**Written submission from
Evelyn Gigantes**

**Decision on the scope of an environmental
assessment of the proposed Micro Modular
Reactor Project at the Canadian Nuclear
Laboratories Ltd., in Chalk River**

Response to CNSC staff proposed Scope of EA

Exhibit 3-6: The MMR Fuel and Fuel Elements

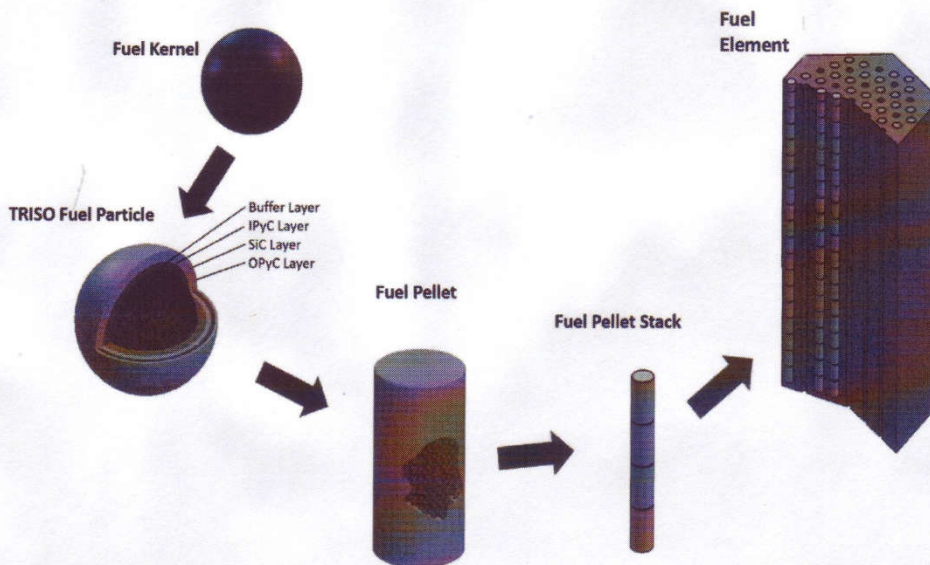
- 2) Staff note on the "Theme" of Reactor Systems and Design that *"the fuel is a prismatic block and not a pebble bed as outlined in Exhibit 3-6 of the project description"*. Page 36, Disposition Table

What is it about the above description and diagram that is supposed to indicate that what is proposed is not “pebble bed” fuel? What is a “prismatic block” and how does it operate differently from a “pebble bed”?

Further, if this is a significantly different fuel in terms of its’ operation, why, under the “Theme” of Accidents and Malfunctions, does staff specifically mention two learned articles cited by the CCRCA, one examining accident scenarios involving pebble bed high temperature reactors, the other examining the operation and waste-management of new pebble-bed nuclear reactors, and then provide the comment: “CNSC appreciates the references provided by CCRCA, and will review them”? p.33, Disposition Table.
